1. To supplement Attachment B, please explain how SROG will monitor the pipeline between the Little Willow Facility and well DJS 2-14 to prevent leaks and/or spills.

2. *The application states on page 10 that a complete water flow testing and water analysis was done for two existing wells prior to developing the Willow Field. Data are presented for one of these two wells. To supplement Attachment E, provide the name, location, or value of Total Dissolved Solids for this other well.*

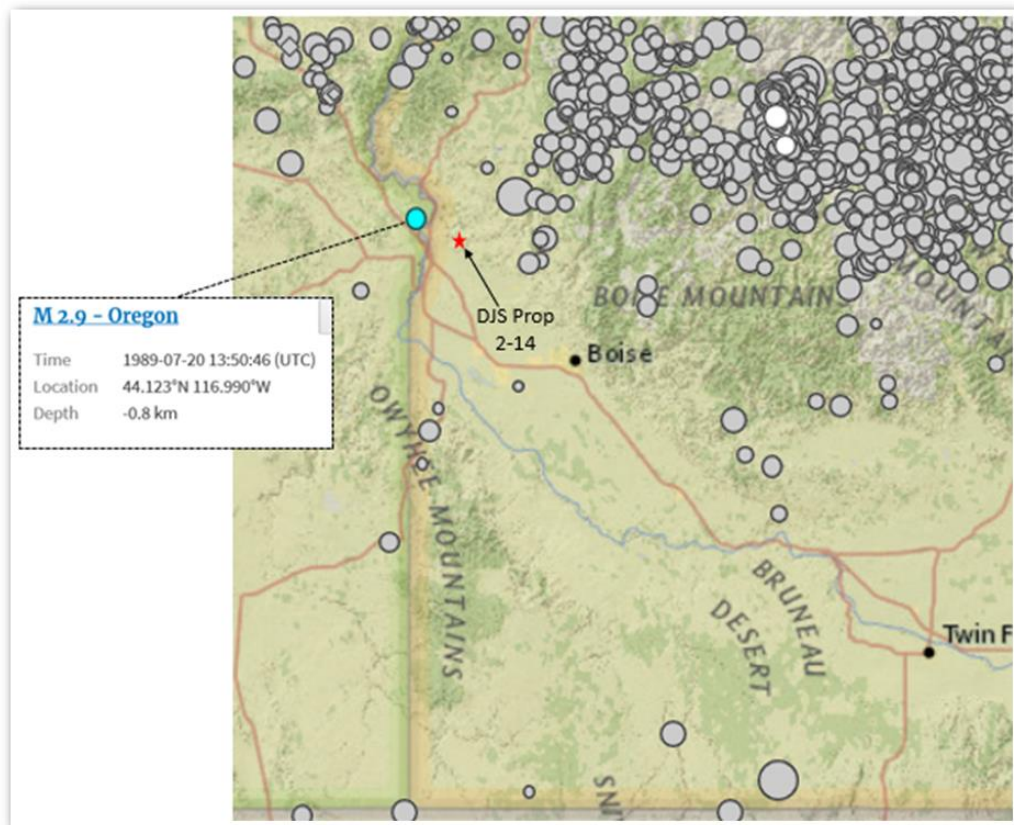
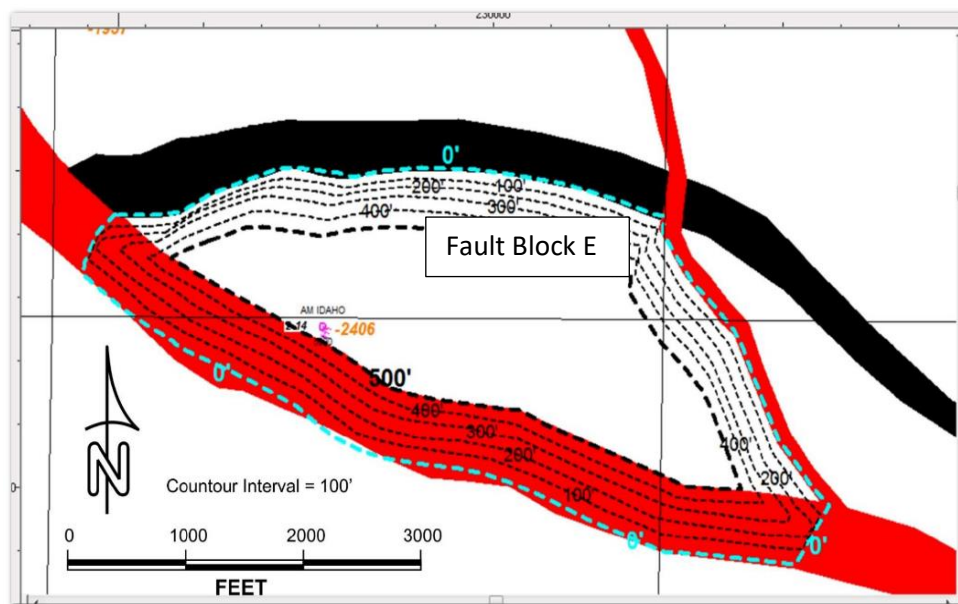
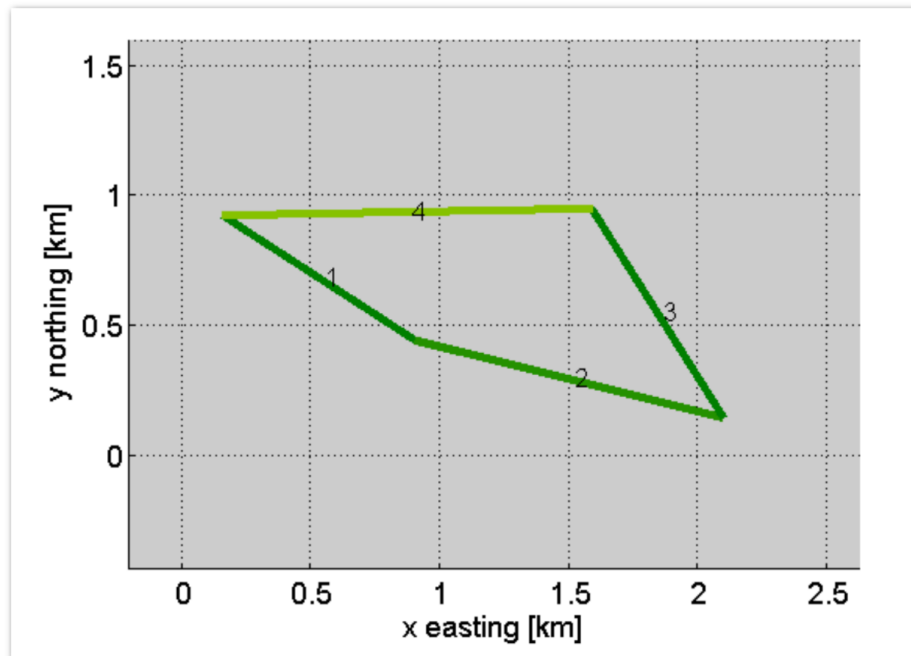
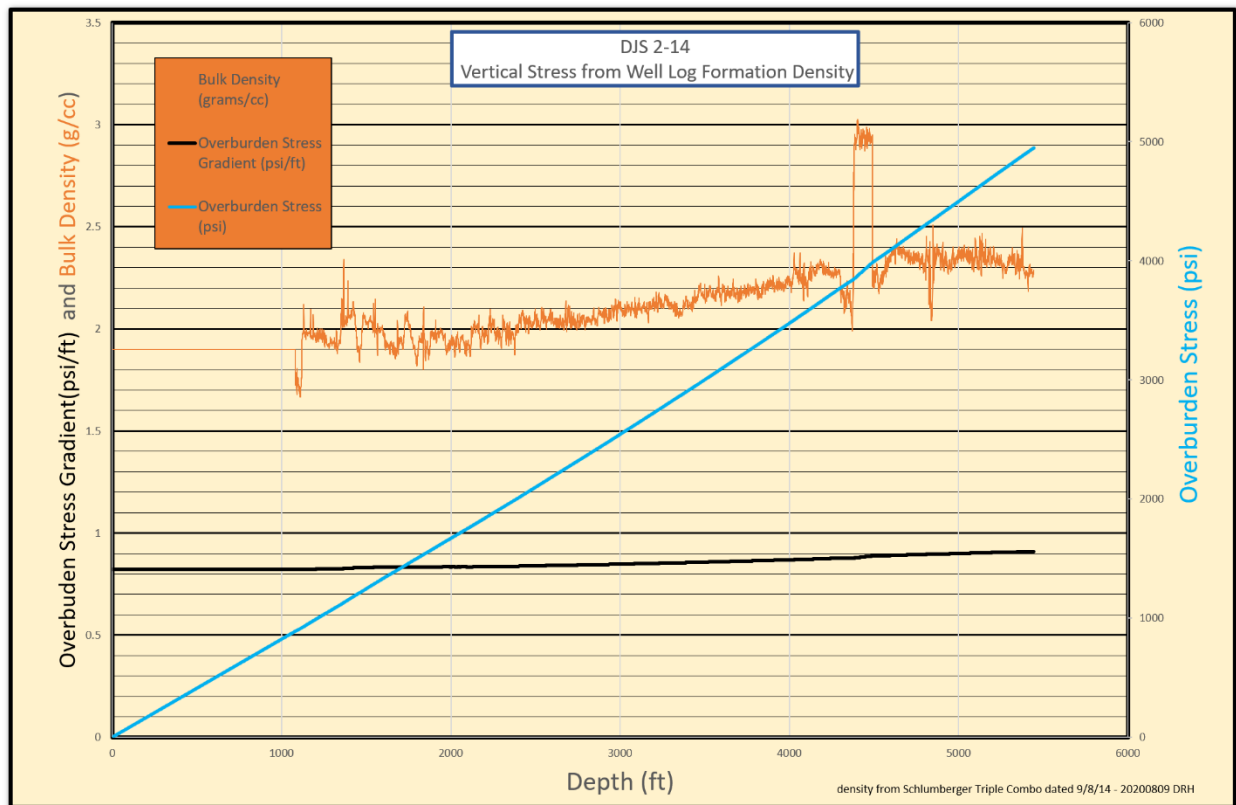
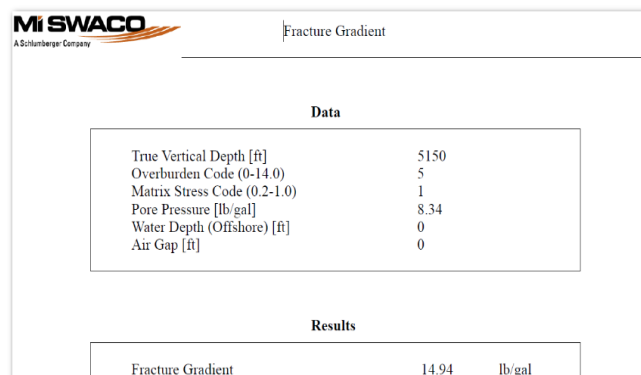
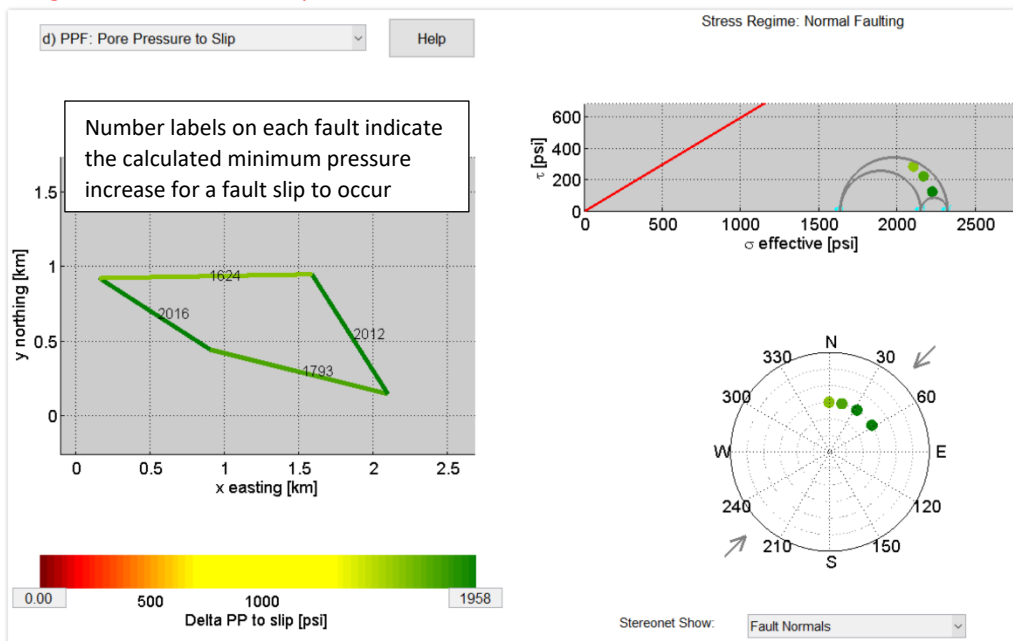
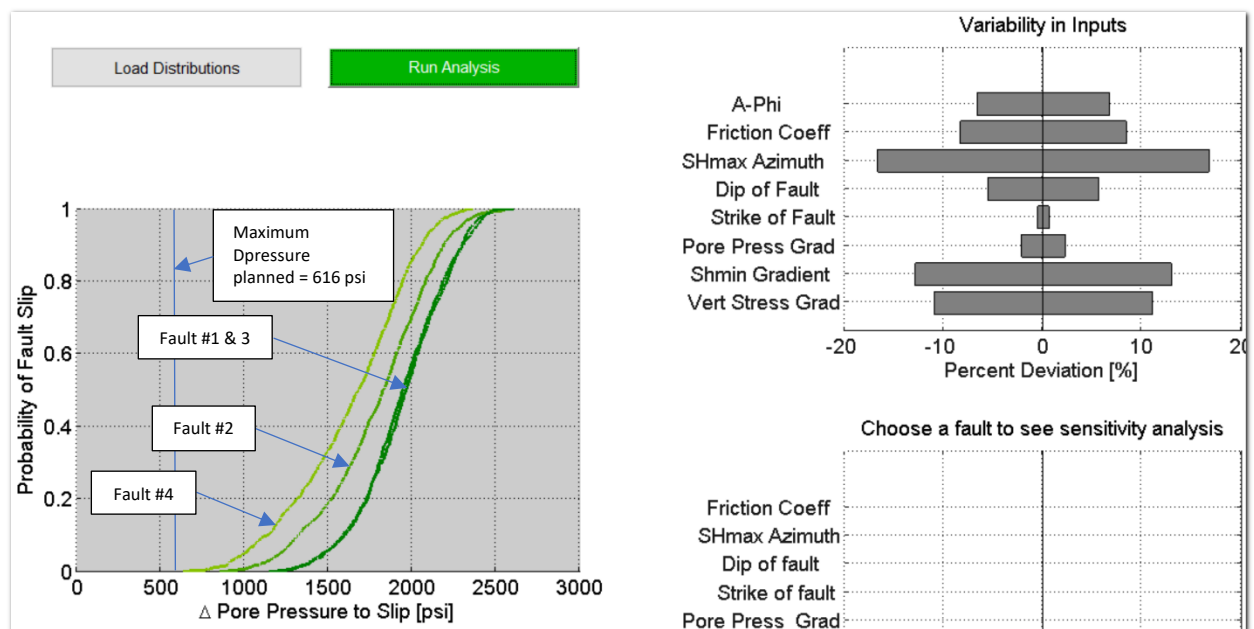
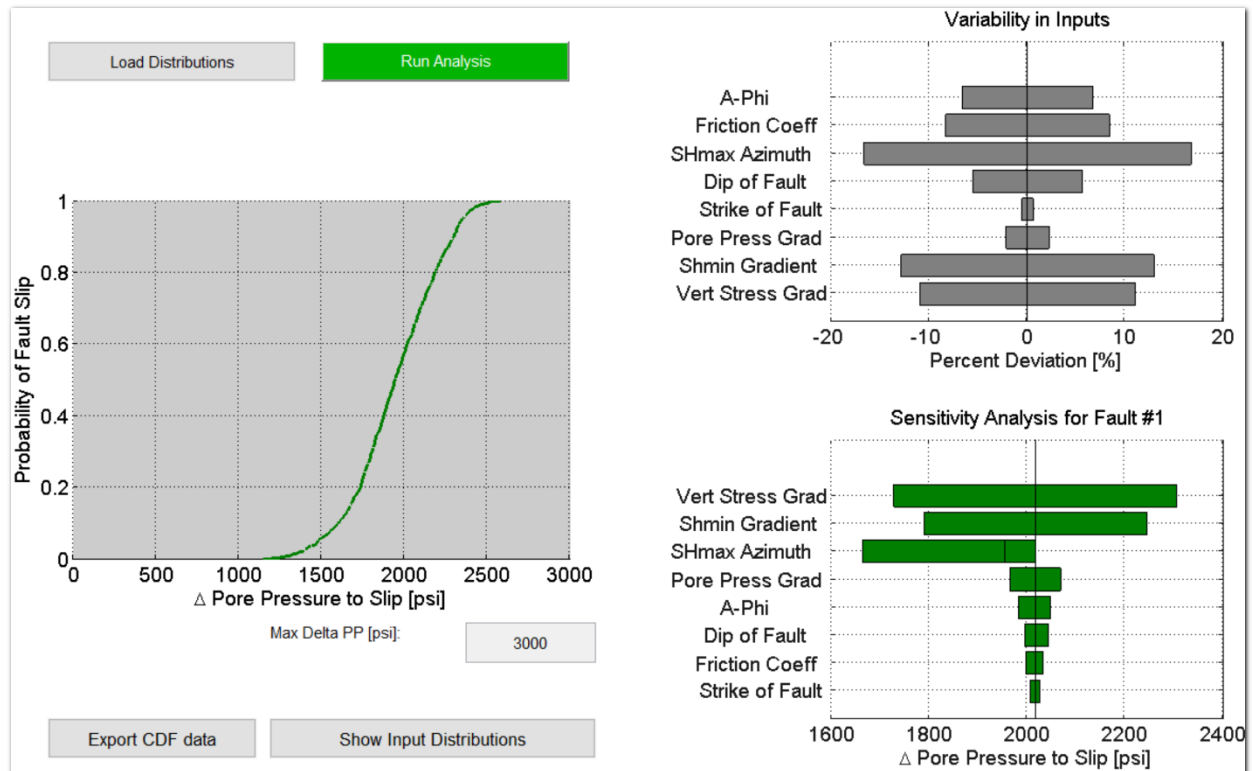
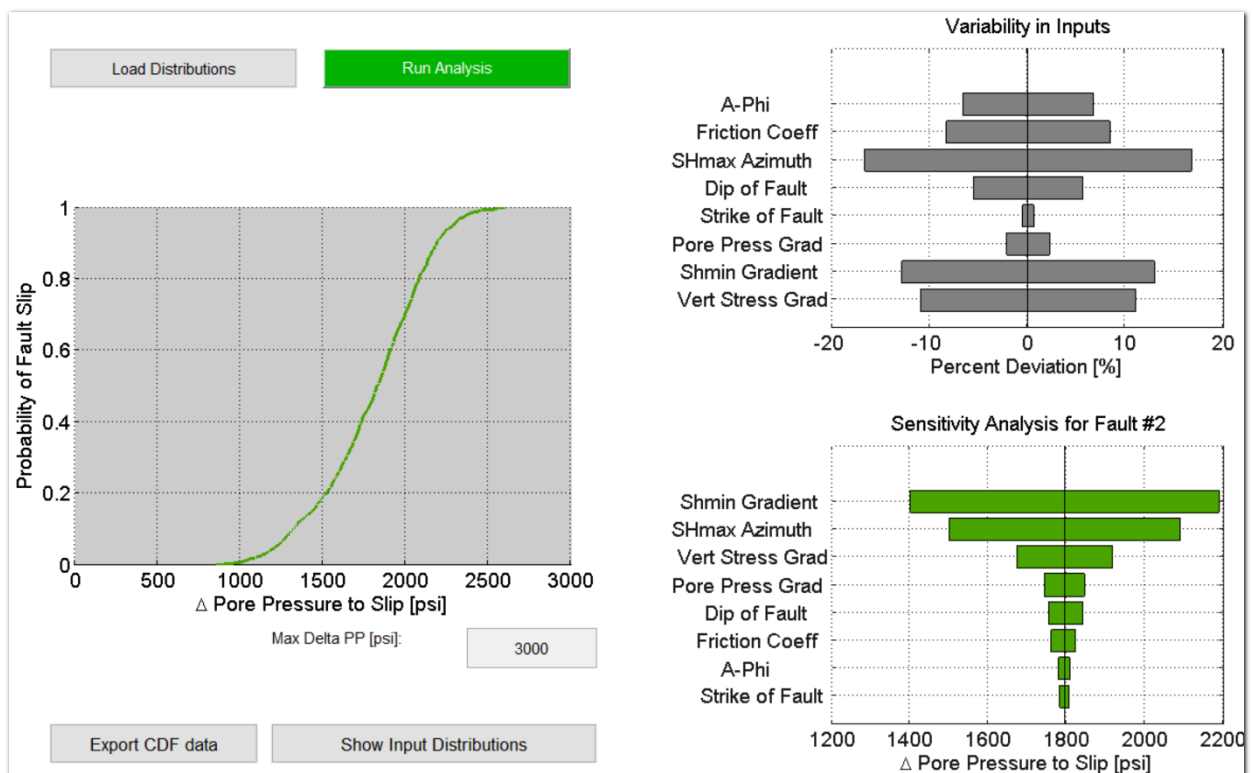
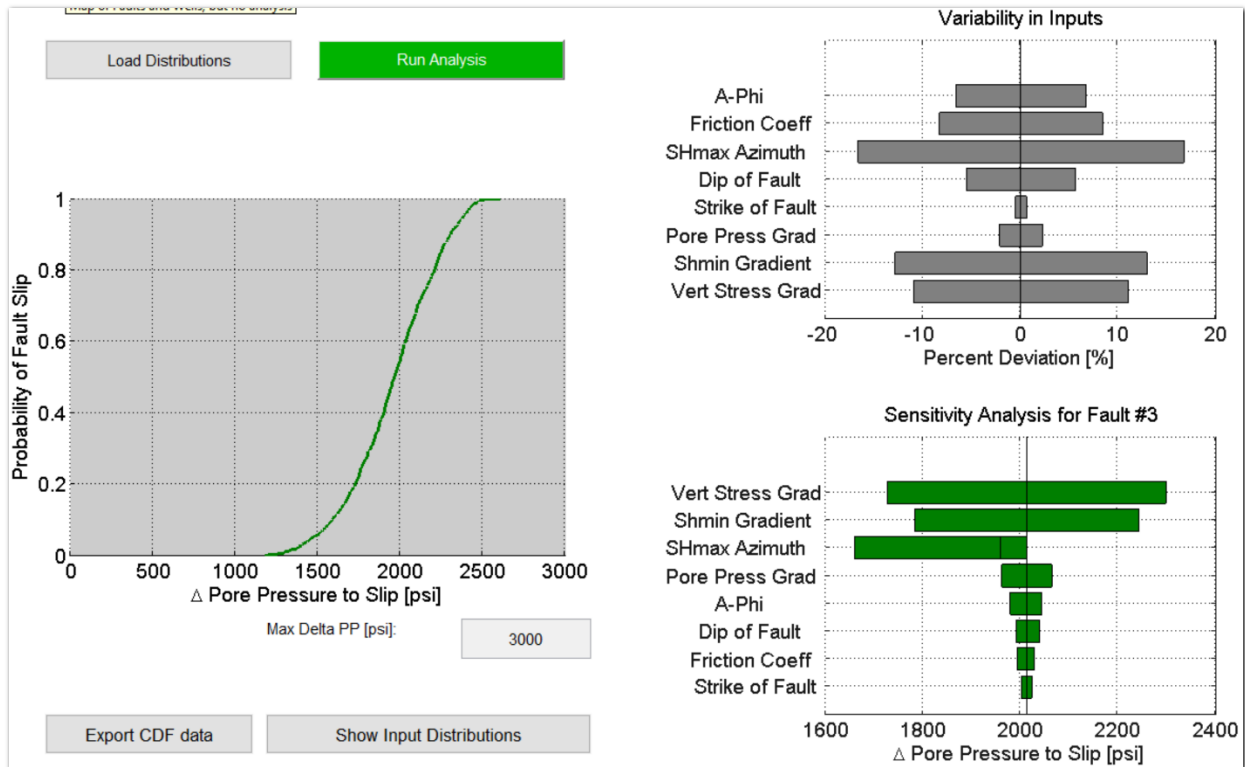
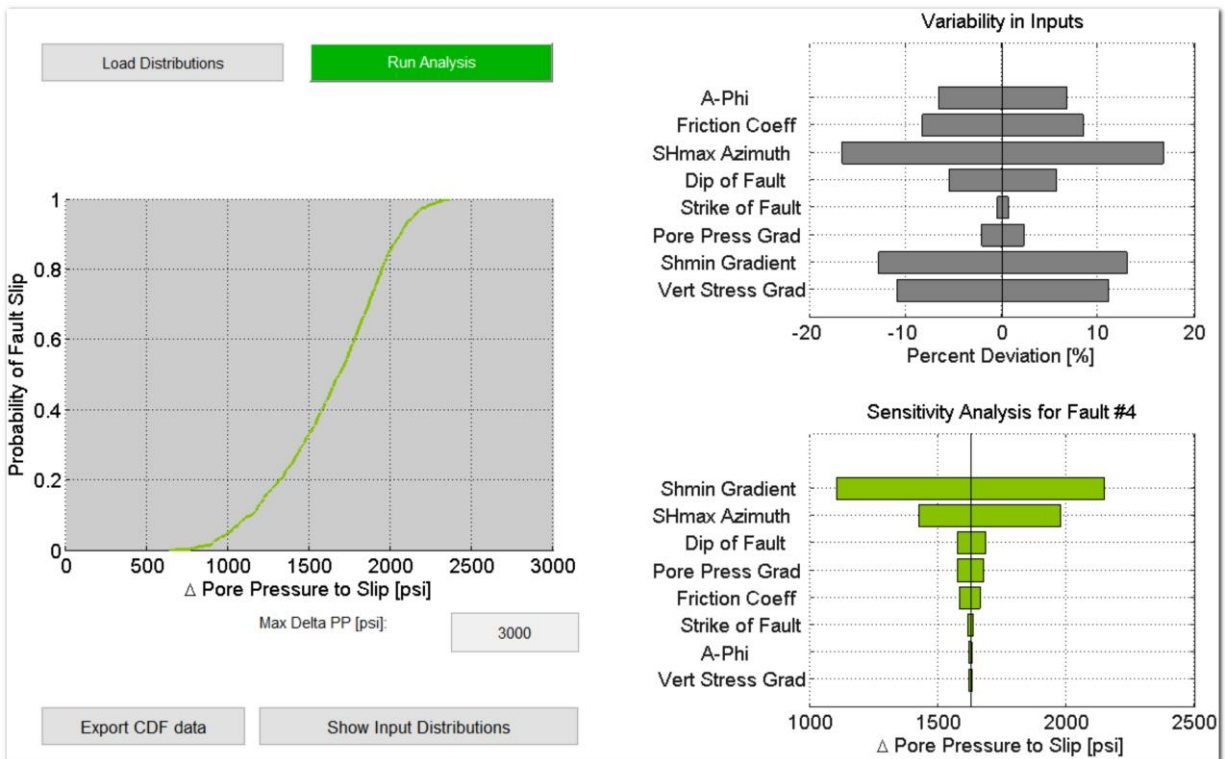
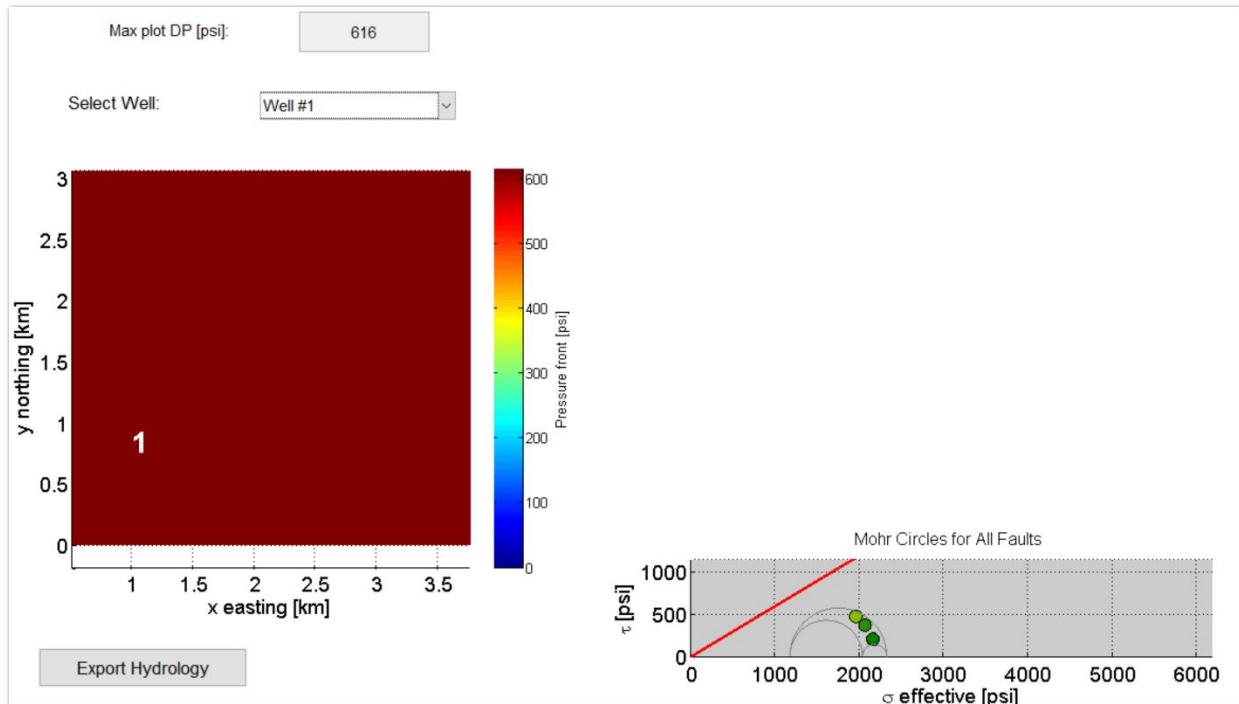
8. To supplement Attachment G, provide information regarding the stability of the faults identified in the permit application. If possible, provide a fault slip analysis supported by fault geometry, downhole stresses, and other relevant factors.

A probabilistic fault-slip potential analysis was performed on the faults that create the boundary of the proposed Fault Block E and the results indicated that no slip will occur, based on the maximum proposed reservoir pressure increase of 616 psi as proposed when calculating injection capacity. Details of the analysis are discussed below.

The results of the base geomechanical FSP analysis is shown below in **Exhibit 8-12** with a presentation that shows a map of the faults with the pore pressure to slip posted on each fault, along with a Mohr Circle and a stereonet with the fault normals. The pore pressures to slip range from 1624 – 2016 psi.
